**UNITED STATES DEPARTMENT OF COMMERCE
Patent and Trademark Office**

09/115,764 07/15/98 REASONER M 65.748-449

Office Action Summary

REASONER

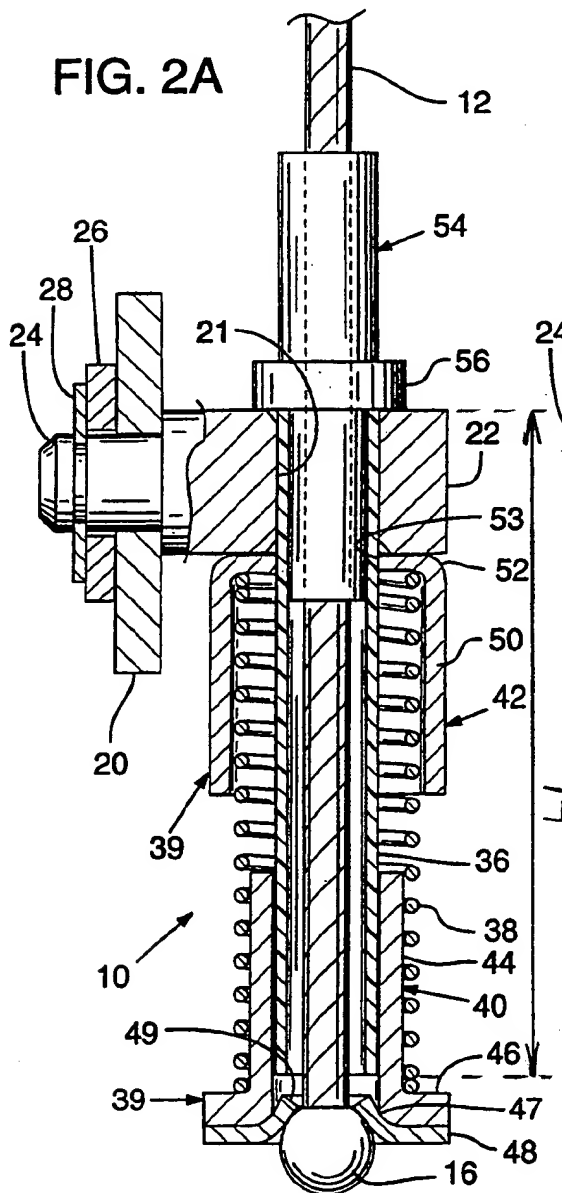
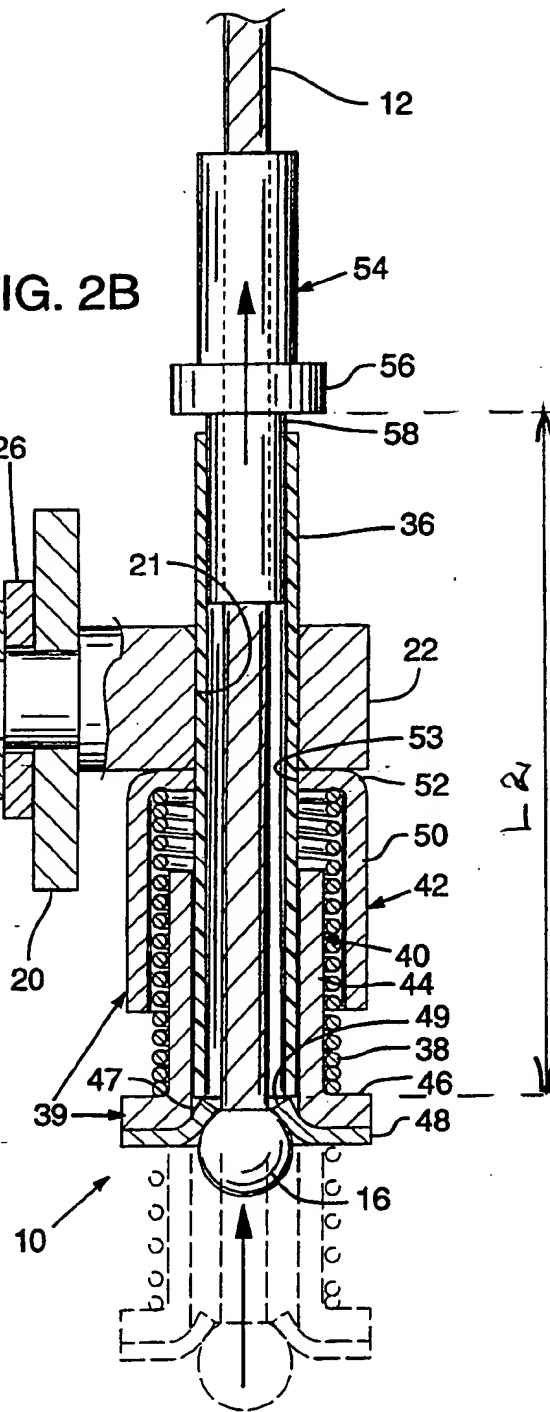
Regarding claim 17, as the spring 38 is compressed axially (Fig. 2B), the first conduit 36 is pulled and the second conduit 58 (i.e., the fitting 54) moves away, consequently, the overall length of the conduit sections 36 and 58 are inherently lengthened. See lines 18-30 of column 7. Further, as the spring 38 is expanded axially (Fig. 2A), the first conduit 36 is retracted backwardly and the

second conduit 58 (i.e., the fitting 54) moves forwardly until the fitting 54 is stopped by the pivot coupling 22, consequently, the overall length of the conduit sections 36 and 58 are inherently shortened. See lines 47-53 of column 7 and the Exhibit I.

NOTE THAT L1 IS SHORTER THAN L2 AS MEASURED BY A RULER
EXHIBIT - I

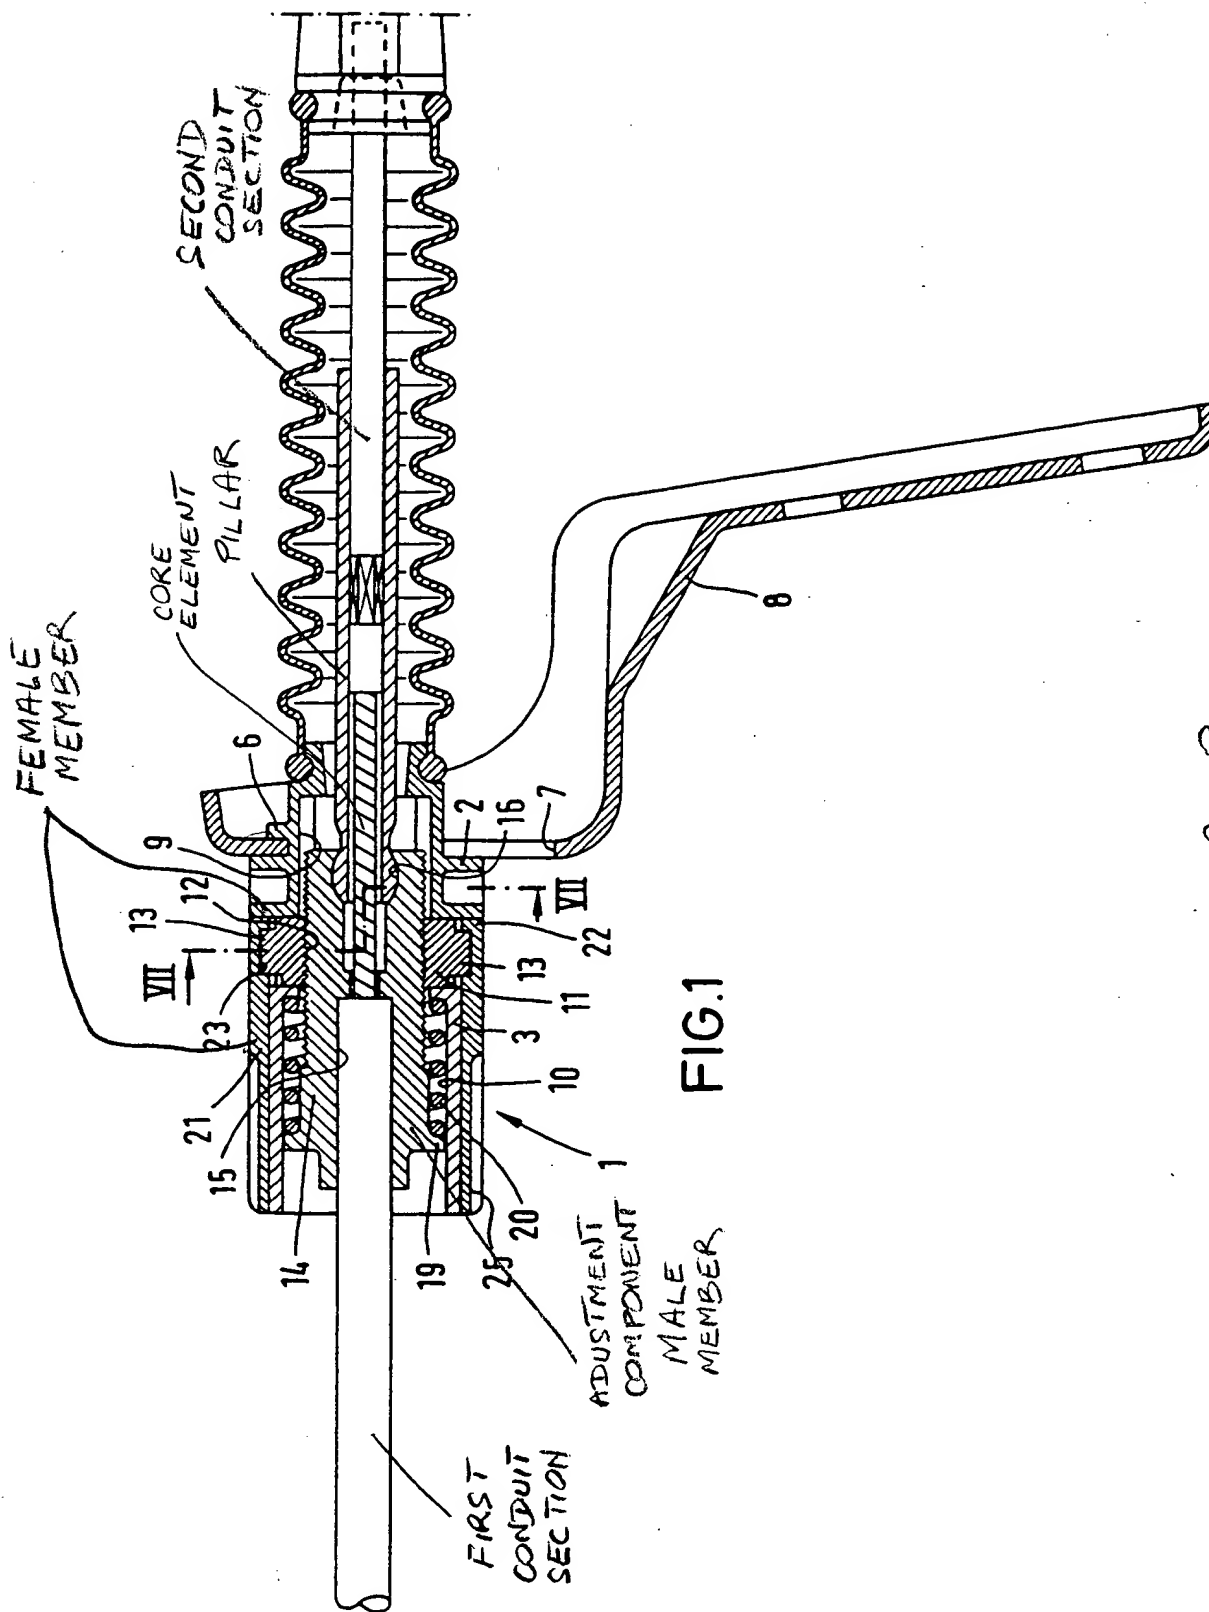
a retainer (a protruding flange) 52 for retaining the spring 38 (i.e., as a seat for the spring 38. *Ibid.*, column 4, line 49 *et seq.*) in compression on one of the members 40 and 42, the members 40 and 42 including an abutment 46 for reacting with the spring 38 in place of the retainer 52 to bias the members 40 and 42 together in the direction to shorten the overall length of the conduit sections 36 and 58 as seen in the Exhibit I attached.

Applicant's Modified Exhibit likewise missed the point because the examiner did not call the fitting 54 as the conduit section as applicant alleged. As plainly seen in the Exhibit attached, the conduit sections 36 and 58 are shortened as fully explained in the Office action on August 16, 1999.
